Re: Cal. No. 2019-89-A; 2019-94-A
Premises: 36 West 66th Street

We are land use counsel to West 66th Sponsor LLC, the owner of the property at 36 West 66th Street. We are submitting the enclosed Statement on behalf of West 66th Sponsor LLC, in response to the referenced appeal applications by Landmark West! and the City Club of New York et al.

This appeal challenges the Department of Buildings' April 5, 2019 approval of Post-Approval Amendments to permit 121190200-01-NB. For the reasons set forth in the enclosed Statement, we respectfully request that the Board affirm the Department of Buildings' determination.

At the request of the 10 West 66th Street Corporation and Landmark West!, a community-based organization that promotes responsible development on the Upper West Side, I have reviewed the zoning diagram and related materials for the new building under construction at 36 West 66th Street (AKA 50 West 66th Street). My firm regularly consults with land owners, architects, community groups and Community Boards on the New York City Zoning Resolution and I have been a member of the American Institute of Certified Planners for the past 21 years.

Summary of the July 26, 2018 ZD1

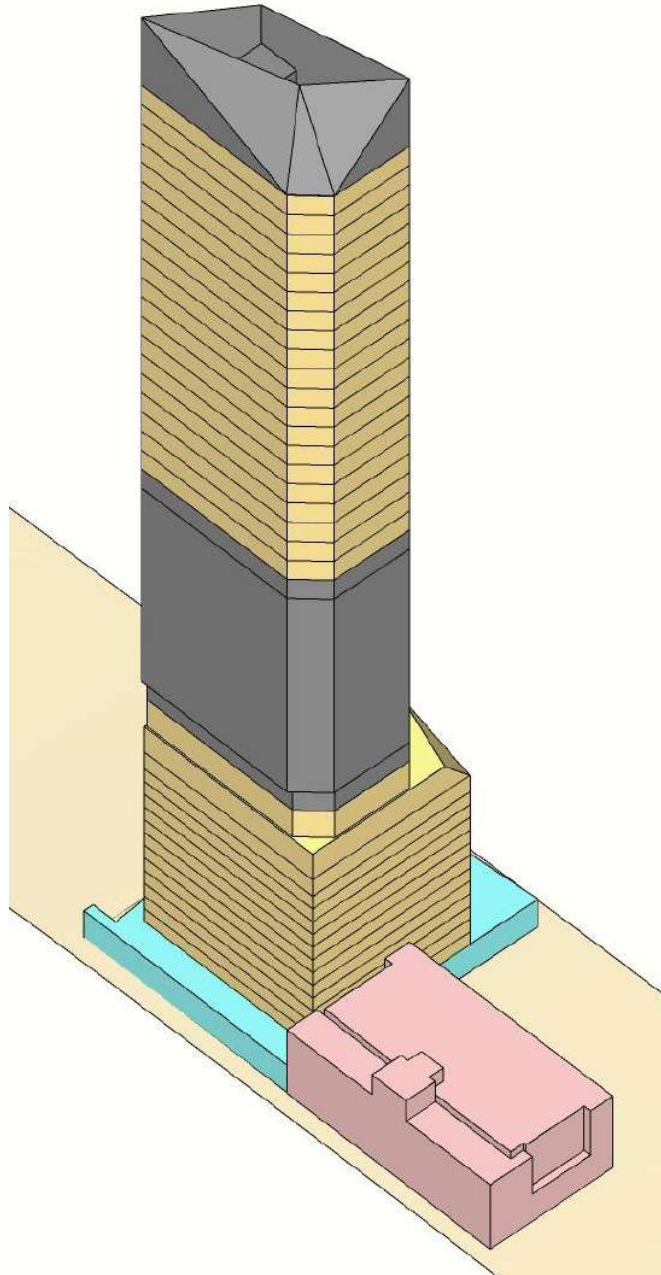
There are several deficiencies in the drawings and design. Review of issue 2 should be expedited, as it relates to building safety.

- 1) The ZD1 is not current and has errors. A new ZD1 or ZD1A should be filed.
- 2) The FDNY has unanswered questions regarding the safety of interbuilding voids. The Commissioner should not approve an unsafe building.
- 3) Tower coverage and bulk packing are calculated on different parts of the zoning lot. They must be linked.
- 4) Areas claimed for mechanical exemptions should be proportionate to their mechanical use.
- 5) The small inner court is too small.

The ZD1 section drawing shows a 42nd floor, which appears to be a roof level. There is neither a 42nd floor, nor a roof level shown in the Proposed Floor Area table. Further, the Proposed Floor Area table reads that the project proposed is 9.24 FAR. This is an error, as it omits all existing floor area to remain on the zoning lot while counting the lot area of the entire zoning lot. The actual proposed FAR is 10.03 (548,541 ZFA proposed / 54,687 SF of lot area). The difference is not trivial and amounts to over 43,000 ZFA that is missing from the table.

At minimum, a new ZD1 (or a ZD1A) that demonstrates FAR compliance with this additional zoning floor area, corrects the mezzanine in the table, removes the 40th and 41st floors, adjusts floor area sums in the Proposed Floor Area table, includes existing floor area to remain in the Proposed Floor Area table, updates the section, plan and elevation to describe the building being proposed, and incorporates any other changes not detailed herein, is required. Alternatively, if the DOB agrees that the floor area in the synagogue mezzanine should be classified as zoning floor area, then it should issue an intent to revoke the zoning approval.

Actual tower-on-base proposal at 249 E. 62nd Street

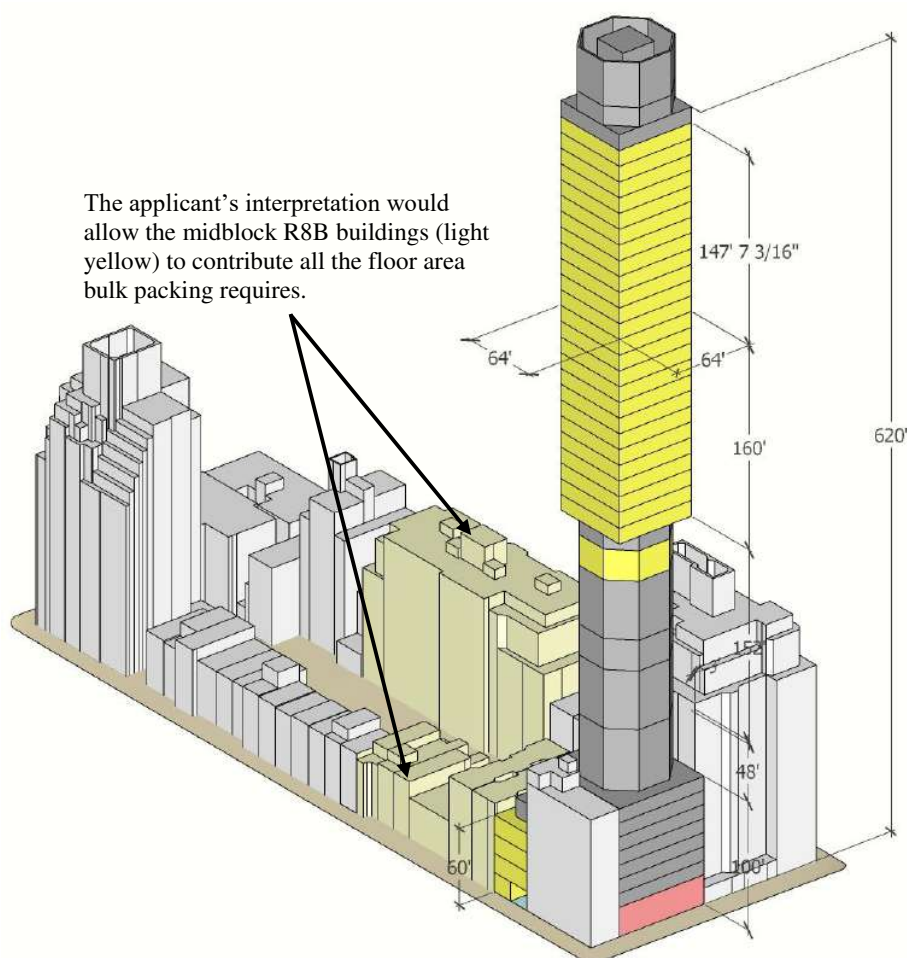
This is another R10 equivalent tower-on-base building with a massive void. Here, the R10 equivalent portion of the lot extends only 100 feet from the wide street the tower faces. If all floor area on the zoning lot under 150 feet can be counted for bulk packing outside the R10 equivalent portion of the lot, and the tower is only counted on the R10 equivalent portion of the zoning lot, then the zoning lot can be expanded to cover much of the block. If that is done, then *all* floor area under 150 feet, with the exception of the ground floor of the new building will be in buildings to stay on the lot. This zoning lot would require no transfer of development rights and would not impair the future development potential of the existing developments in the height limited mid-blocks. The following shows how such a building might be massed out:

Possible tower on base massing if the area for tower coverage is divorced from the area for bulk packing

The existing buildings added to the zoning lot are shown in light yellow in the midblock. They contribute substantially all the floor area under 150 feet that this new building needs so that the floor area generated on its own lot can be placed at levels higher than 150 feet. In the prior example there were 13 residential floors over 150 feet. With this interpretation and large zoning lot, 26 residential floors in the main portion of the building are over 150 feet. This example shows expanded mechanical floors acting as a platform to raise the building to 150 feet so that the height can be maintained. It could have just as easily been a single floor designed to be 150 feet floor-to-floor, which while sounding absurdly unrealistic, is actually 11 feet shorter than what the applicant is actually proposing on the 18th floor of their building.

Actual tower-on-base proposal at 249 E. 62nd Street

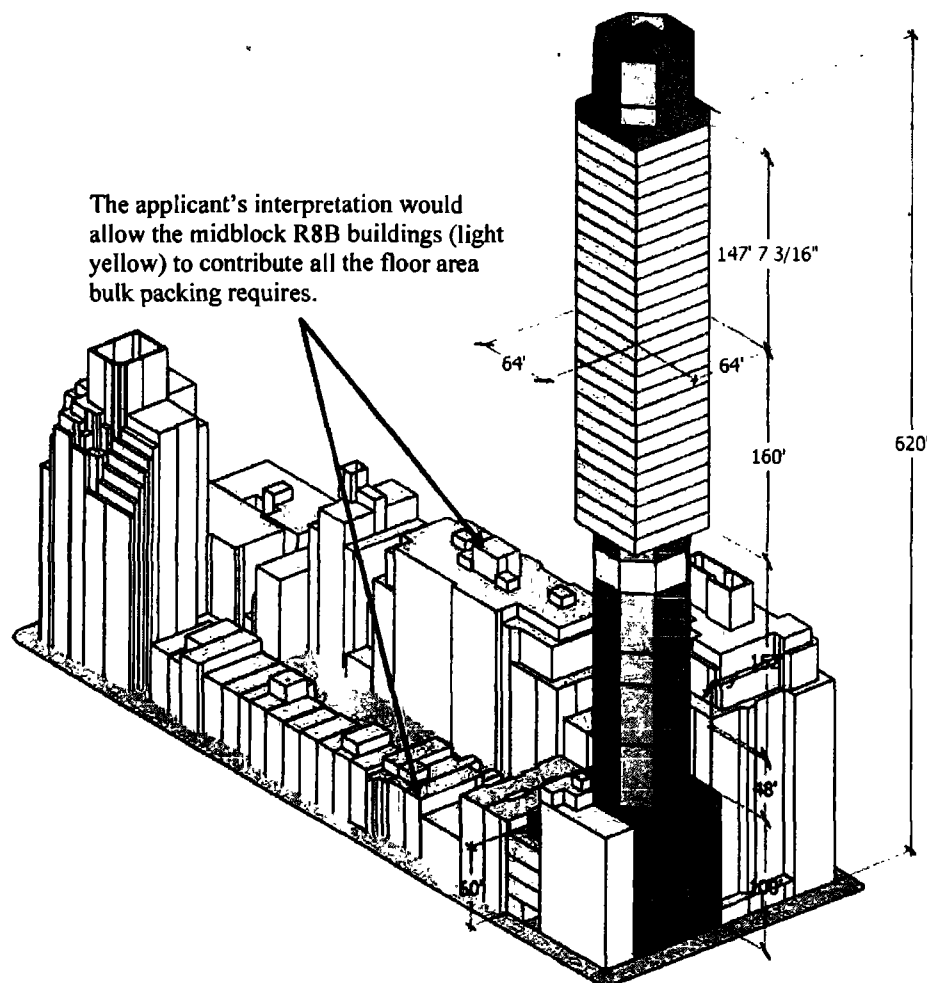
This is another R10 equivalent tower-on-base building with a massive void. Here, the R10 equivalent portion of the lot extends only 100 feet from the wide street the tower faces. If all floor area on the zoning lot under 150 feet can be counted for bulk packing outside the R10 equivalent portion of the lot, and the tower is only counted on the R10 equivalent portion of the zoning lot, then the zoning lot can be expanded to cover much of the block. If that is done, then *all* floor area under 150 feet, with the exception of the ground floor of the new building will be in buildings to stay on the lot. This zoning lot would require no transfer of development rights and would not impair the future development potential of the existing developments in the height limited mid-blocks. The following shows how such a building might be massed out:

Possible tower on base massing if the area for tower coverage is divorced from the area for bulk packing

Detail of plan showing the small inner court

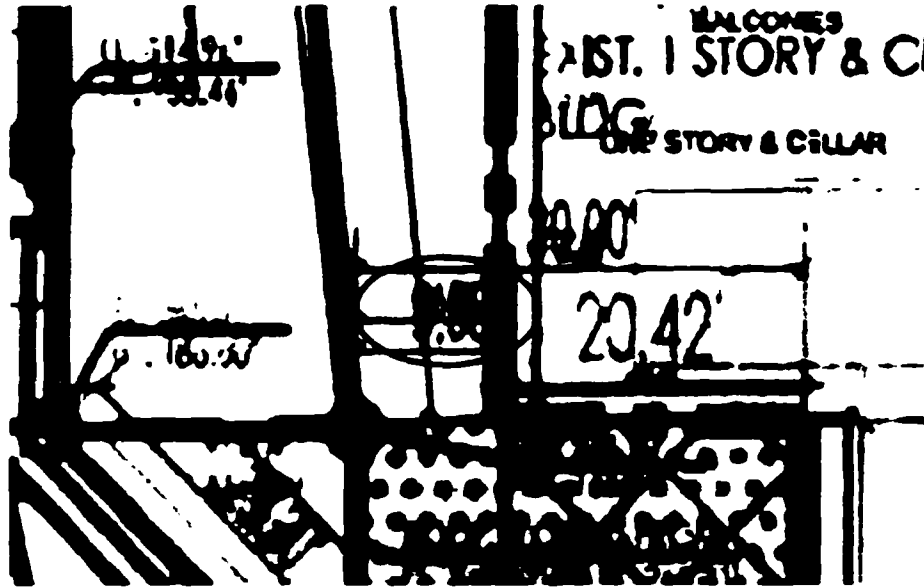
The ground level open space shown below is not a side yard because it does not extend to the front yard line. It is surrounded by building walls and a lot line, so therefore, it must be an inner court. While the numbers are hard to read on the ZD1, it appears that the plan shows the narrowest dimension for this small inner court to be just over nine feet.
